OUTCOMES COMMITTEE

SUBJECT:

Issue: Amendment to Draft Site Specific Development Control Plan – Wetherill Park Market Town
Premises: Lot 5 DP 714281 known as 13 – 21 Rossetti Street, Wetherill Park
Applicant: Rhodes Haskew and Associates
Principals: Gary Rhodes and David Haskew
Owner: Ross Trimboli
Zoning: Zone 2(a) Residential A (Fairfield Local Environmental Plan 1994)

ASSESSMENT OF AMENDMENTS TO THE DRAFT SITE SPECIFIC DEVELOPMENT CONTROL PLAN

Figure 2 – Amended indicative building envelope

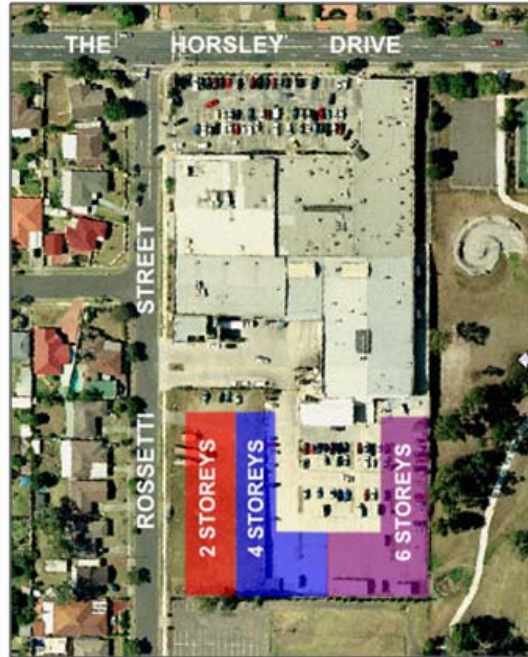
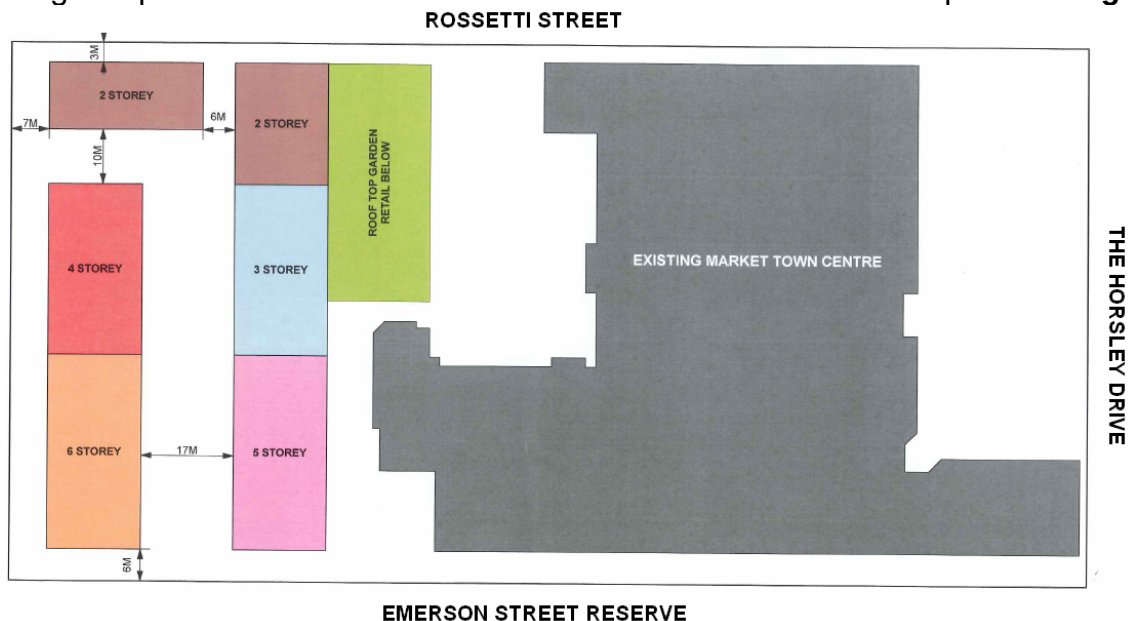
The previous draft SSDCP proposed a built form for the apartment building that was essentially a “U” shape with a north facing central courtyard with a “single aspect”, north, west and east units facing inwards along unbroken but mildly articulated facades (**Figure 1** illustrates the original indicative building envelope).

The applicant has amended the original built form, as depicted in **Figure 1** above, and is proposing 3 separate built forms on the site. The revised built form is depicted in **Figure 2**.

The proposed built form massing has moved away from a single monolithic “U” shaped structure by proposing 3 separate building elements, with some of the benefits outlined above. The amendment also makes for the following provisions as a consequence to the revisions to the massing of buildings:

- Remove the zero setbacks that were previously proposed along the southern and eastern boundaries of the subject site as the SSDCP now proposes a 7 metre setback along the southern boundary and a 6 metre setback along the eastern boundary.
- Inclusion of deep soil zones along the southern boundary and the eastern boundary fronting Emerson Street Reserve enhancing the interface with the subject site.
- Improve the interface of the northern facade with the existing commercial development on Lot 4 DP 714281.
- Revised vehicle access arrangements (access issues are further discussed later in the report).

The revised built form proposes a variation to the NSW RFDC in regards to separation for buildings between 5-8 storeys. The NSW RFDC requires a distance of 18 metres separation between 5-8 storey buildings, this draft SSDCP proposes a distance of 17 metres.

Council Officers consider the variation acceptable given the following factors:

- The proposal limits the applicable building elements to 5 and 6 storeys
- The 5 storey building is located on the northern part of the site with the 6 storey element located on the southern side of the development which will allow for greater solar penetration (than would be the case if both buildings were 6 storeys in height or the northern building was 6 storeys).

- The building envelope has been tested to ensure that a minimum of 70% of all dwellings achieve at least 3 hours solar access between 9am and 3pm mid winter.
- As mentioned earlier, the revised built forms allows for a 7 metre setback to the southern boundary (from the zero setbacks previously proposed).

Council Officers consider that the proposed amendments to the draft SSDCP in relation to the built form represents an improvement to what was previously proposed, specifically in terms of reducing overshadowing and providing urban design treatments along the southern and eastern boundaries. It is therefore considered that Council has sufficient basis to support the amendments to this aspect of the draft SSDCP.
